ZAYO'S PRINEVILLE TO RENO PROJECT

CPUC MINOR PROJECT REFINEMENT FORM

Date Requested: 16 Oct 2024	Report No.: 11
Date Approved: 11/6/24	Approval Agency: Caltrans, in addition to CPUC
Property Owner(s): Caltrans (State Route 395 ROW)	Location/Milepost: PM M-0.45 to L-136.55 (N to S)
Land Use/Vegetative Cover: Ruderal (maintained highway shoulder near edge of pavement)	Sensitive Resources: Waterways at culverts to be avoided by boring underneath culverts. Rare plant populations being avoided by change in running line. Cultural resources present, being avoided.(See project webmap.)

The proposed change is a shift of the fiber optic running line from previously submitted engineering drawings. The change entails bringing the running line closer to the highway edge of pavement to avoid construction on slope faces and avoid tree driplines in accordance with the approved Caltrans Encroachment Permit. A portion of the change is being made to avoid a rare plant population.

SHEET NO.: 18 OF 105

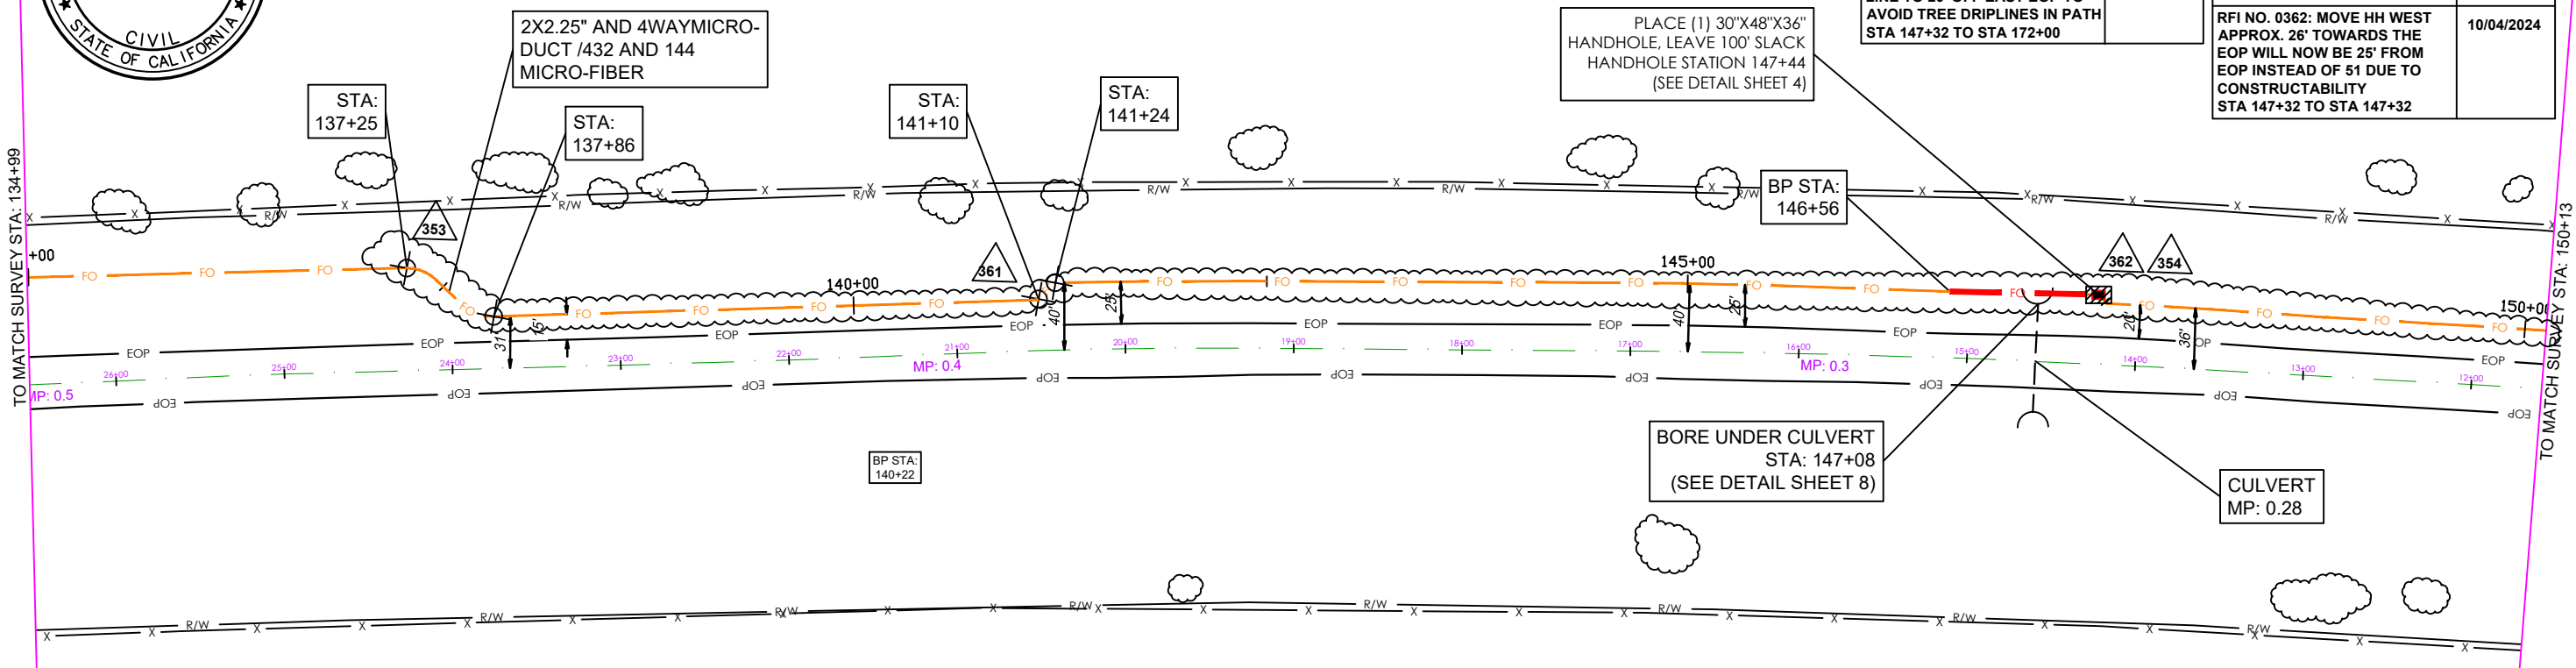
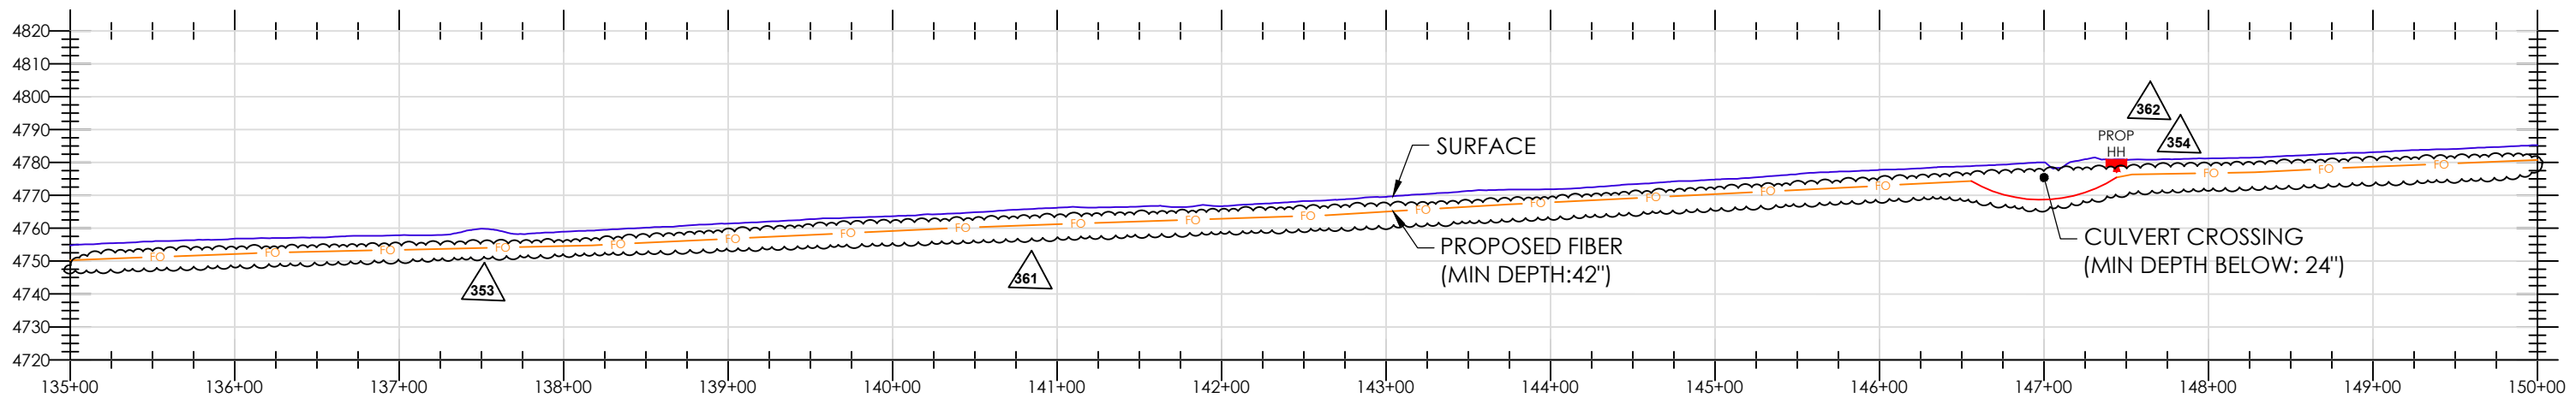
RFI NO. 0353: SHIFT RUNNING LINE IN 30' FROM CURRENT 45' - 49' OFFSET TO AVOID HILLSIDE NEW RUNNING LINE WILL BE 15' OFFSET FROM EOP AVOIDING CLIFFSIDE R/L STA 137+25 TO STA 141+00	10/04/2024	RFI NO. 0361: DEVIATE AT AN ANGLE THE R/L FROM THE PROPOSED 15' AWAY FROM EOP TO 25' AWAY FROM EOP. THE RUNNING LINE WOULD BE MOVED FROM 49' O/S TO 25' O/S AND AWAY FROM THE FACE OF THE HILLSIDE. STA 141+00 TO STA 147+32	10/04/2024
RFI NO. 0354: MOVE RUNNING LINE TO 20' OFF EAST EOP TO AVOID TREE DRIPLEINES IN PATH STA 147+32 TO STA 172+00	10/04/2024	RFI NO. 0362: MOVE HH WEST APPROX. 26' TOWARDS THE EOP WILL NOW BE 25' FROM EOP INSTEAD OF 51 DUE TO CONSTRUCTABILITY STA 147+32 TO STA 147+32	10/04/2024

SHEET NO.: 19 OF 105

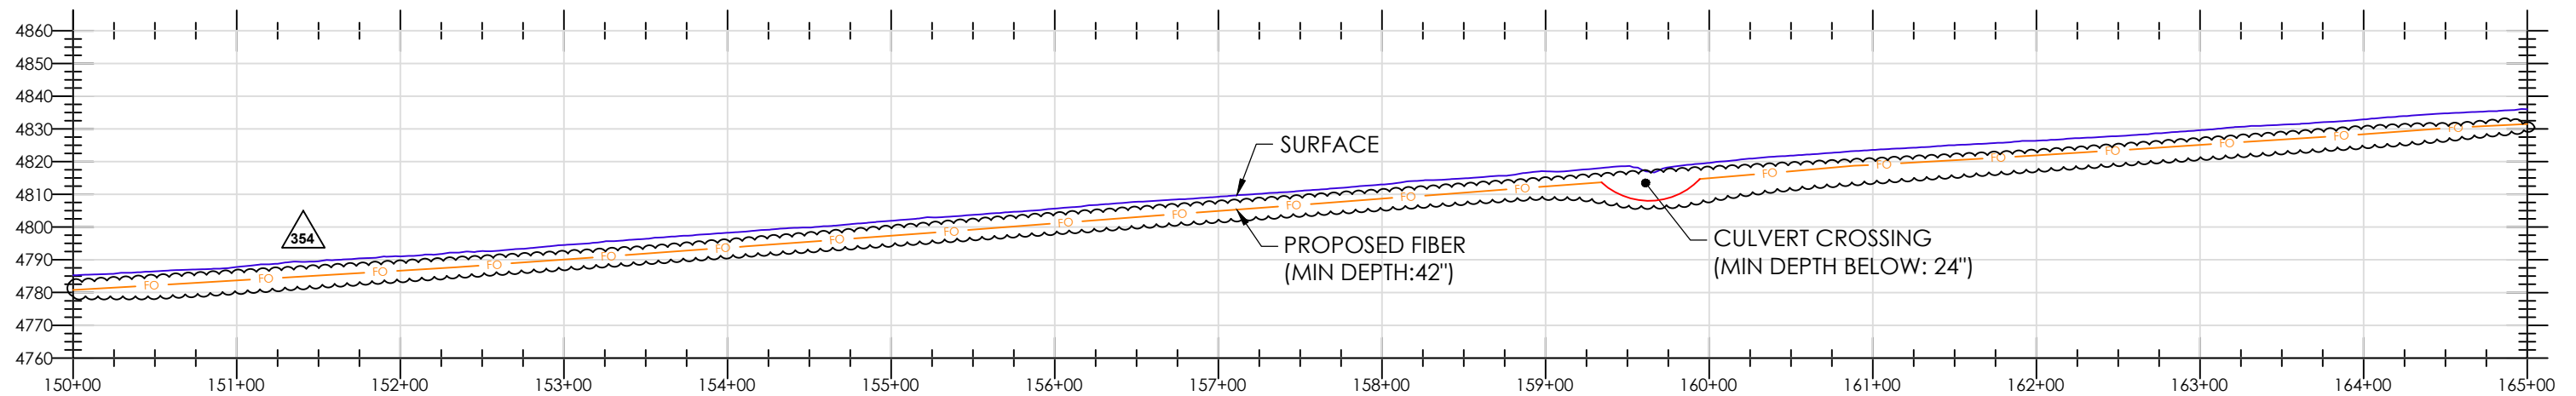
RFI NO. 0354: MOVE RUNNING LINE TO 20' OFF EAST EOP TO AVOID TREE DRIFLINES IN PATH STA 147+32 TO STA 172+00
10/04/2024

BORE UNDER CULVERT
STA: 159+64
(SEE DETAIL SHEET 8)

SHEET NO.: 20 OF 105

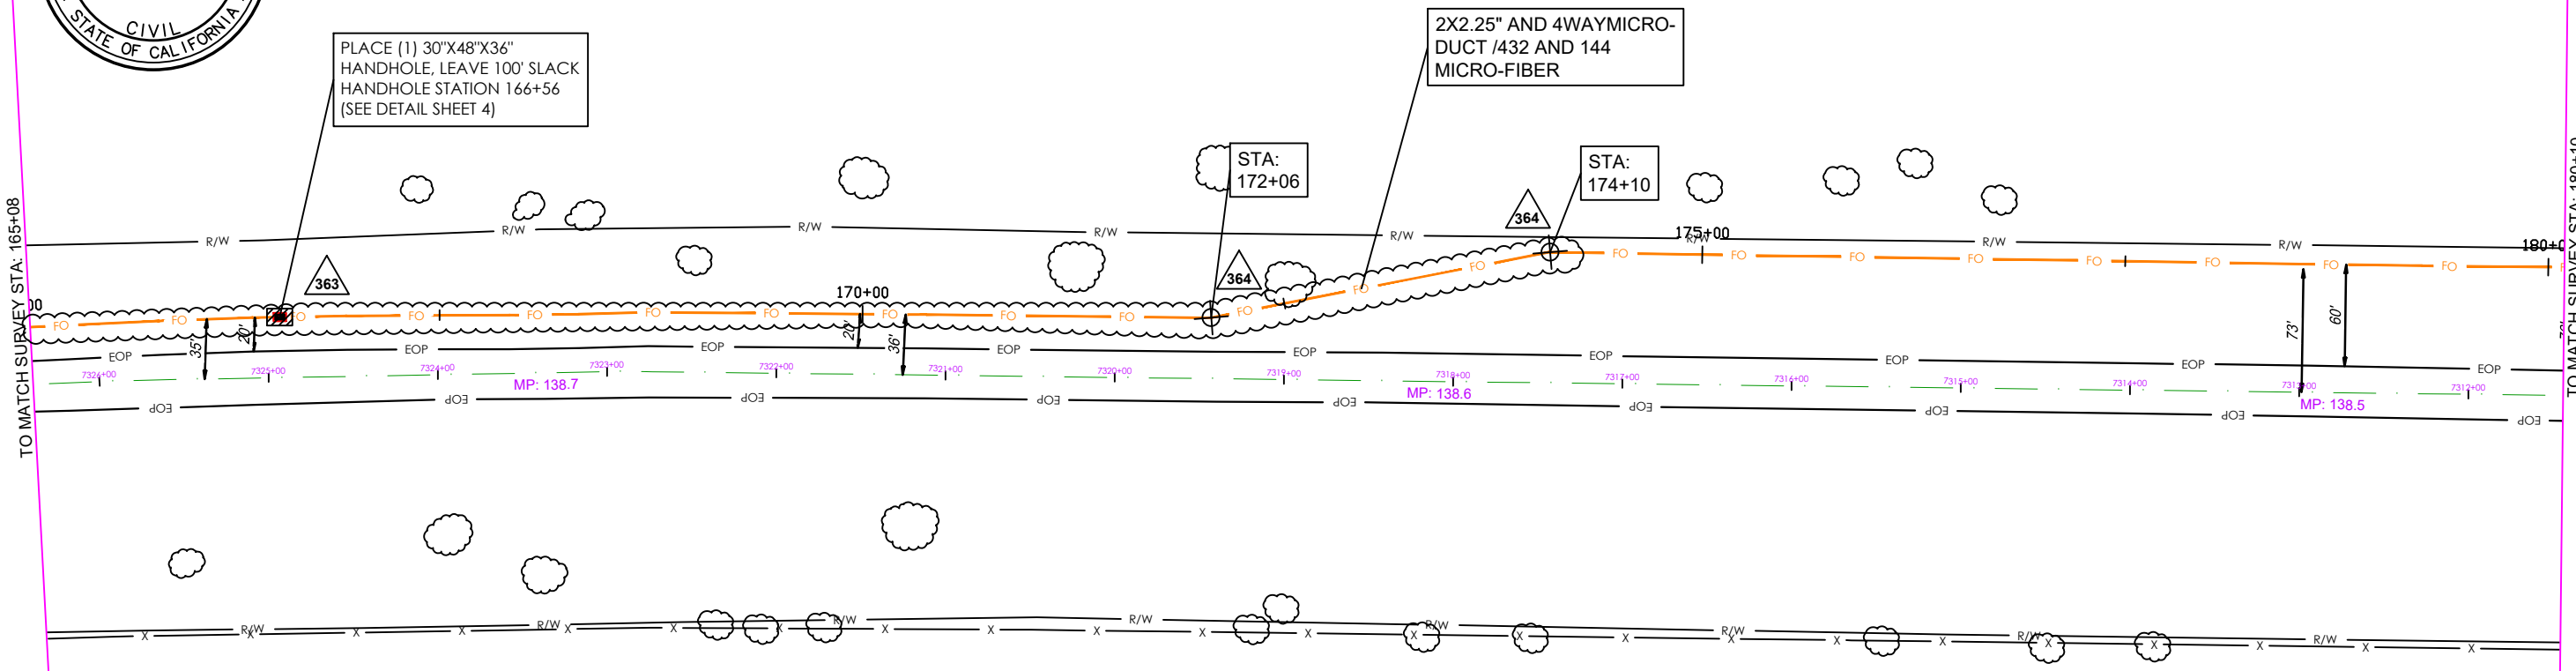
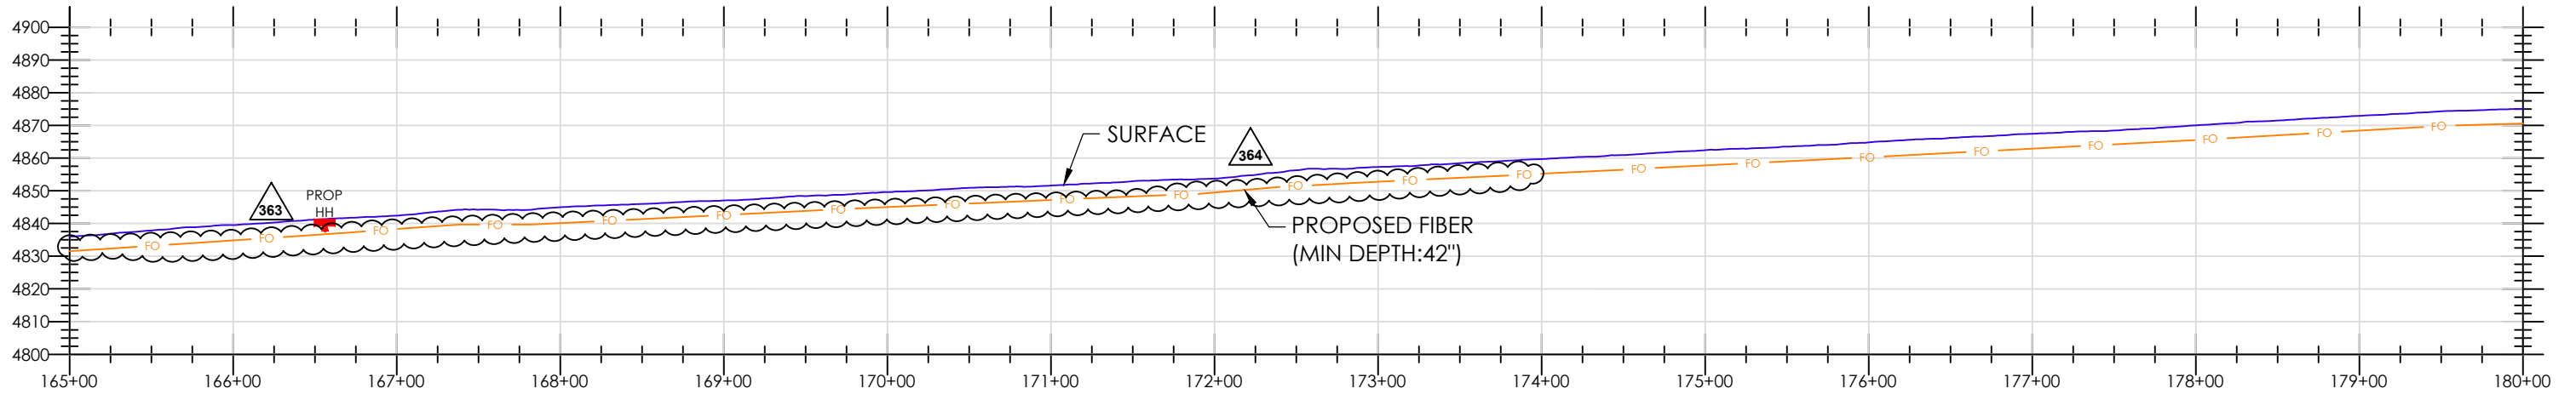
RFI NO. 0363: MOVE HH TO 20' OFFSET DUE TO RUNNING LINE CHANGE AVOIDING TREELINE STA 166+48 TO STA 166+48	10/04/2024
RFI NO. 0364: DEVIATE RUNNING LINE FROM 20' OFFSET BACK TO PROPOSED RUNNING LINE STA 172+00 TO STA 174+00	10/04/2024

SHEET NO.: 21 OF 105

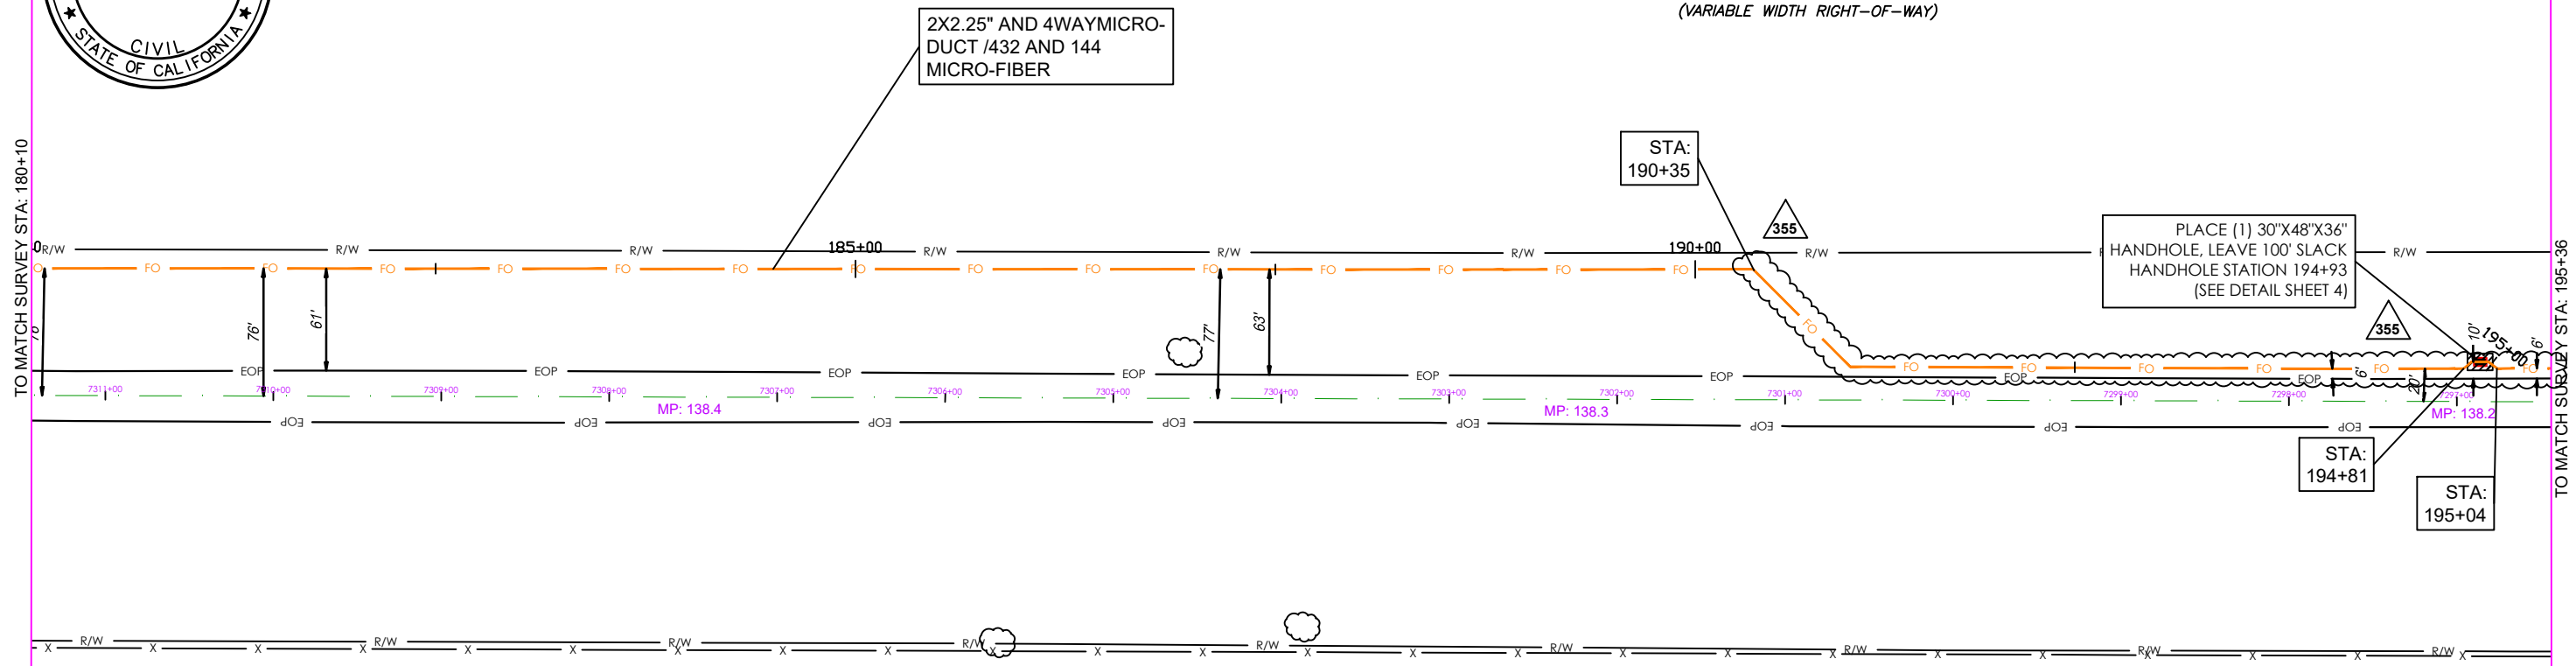
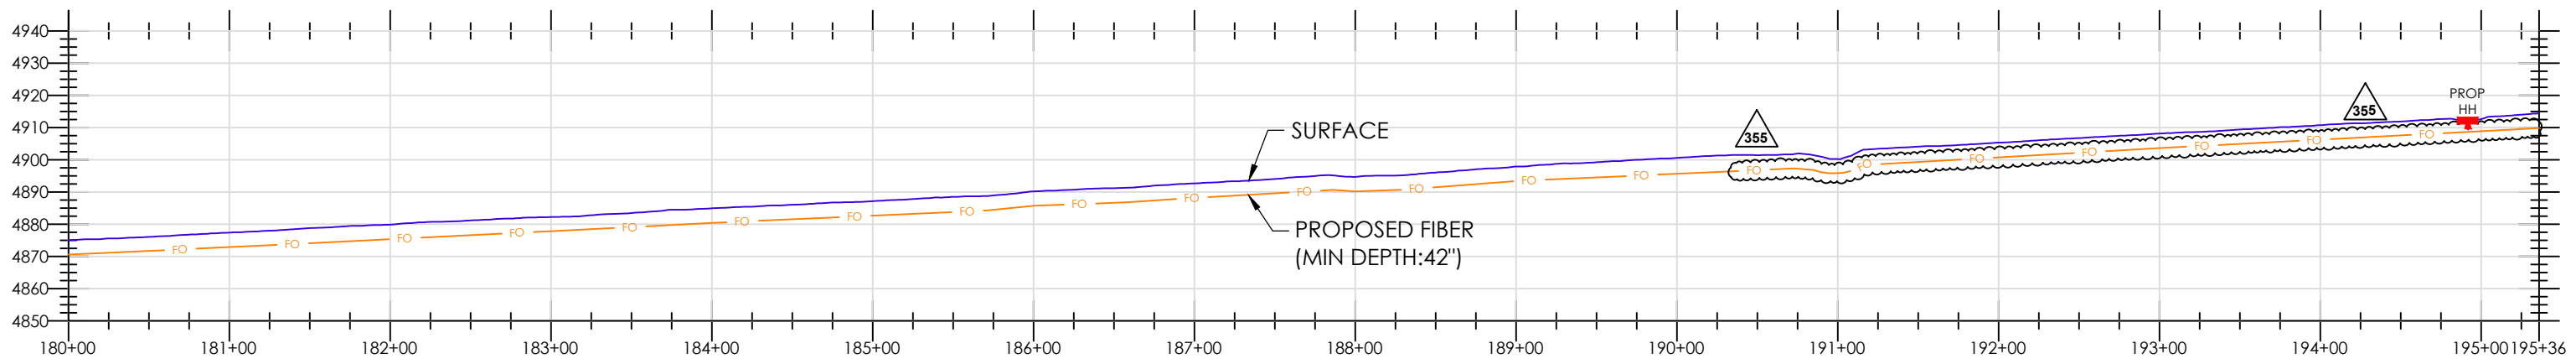
RFI NO. 0355: MOVE RUNNING LINE IN TO 6' OFF EOP TO AVOID RARE PLANTS STA 190+25 TO STA 216+24	10/04/2024
RFI NO. 0355: MOVE HH OUT OF RARE PLANT ZONE STA 190+25 TO STA 194+53	10/04/2024
